CHURCH OF THE MAGDALEN ADDITION
WICHITA, SEDGWICK COUNTY, KANSAS

RE: SUB 2000-24 -- **REVISED** Final Plat of CHURCH OF THE MAGDALEN ADDITION

RE: SUB 2000-24 -- Final Plat of CHURCH OF THE MAGDALEN ADDITION

CASE NUMBER: SUB 2000-24 -- CHURCH OF THE MAGDALEN ADDITION

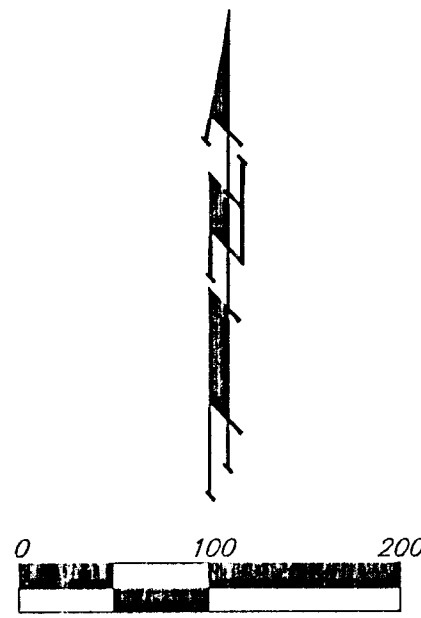
- D. City/County Engineering needs to comment on the status of the applicant's drainage plan. County Engineering has required a copy of the final drainage plan to verify how off-site drainage is to be handled. City Engineering has approved the drainage plan and has required a cross-lot drainage easement. The minimum building elevation appears to be too low.

- E. County/Traffic Engineering needs to comment on the access controls. The plat proposes two access openings along 21st Street North and two access openings along 127th Street East. County Engineering requests that the entry access be coordinated with the streets and entrances on the south side of 21st Street. On the final plat, the dedication of access controls shall be referenced in the plat's text.

- F. County/Traffic Engineering needs to comment on the need for any improvements to perimeter streets. The Applicant shall provide a guarantee for the construction of a left turn bay on 21st Street and the construction of a paved road to County standards on 127th Street East along the plat's frontage.

- G. County Surveying requests a benchmark elevation.
- H. Access to 127th Street East will require a release to cross the pipeline.
- I. The applicant shall submit a covenant regarding the ownership and maintenance of the proposed reserves.

- J. In the plat's text, the word "Reserve" shall be corrected.
- K. The 35' building setback lines along the tapers on the road rights-of-way need to be parallel with the new property lines.

- L. The 35' building setback along 127th Street needs increased to include the pipeline setback with a definite dimension with respect to the plat.
- M. For those reserves being platted for drainage purposes, the required covenant which provides for ownership and maintenance of the reserves shall grant, to the City, the authority to maintain the drainage reserves in the event the owner(s) fail to do so. The covenant shall provide for the cost of such maintenance to be charged back to the owner(s) by the governing body.

- O. The plat's text shall include language that a drainage plan has been developed for the plat and that all drainage easements, rights-of-way, or reserves shall remain at established grades or as modified with the approval of the applicable City or County Engineer, and unobstructed to allow for the conveyance of stormwater.
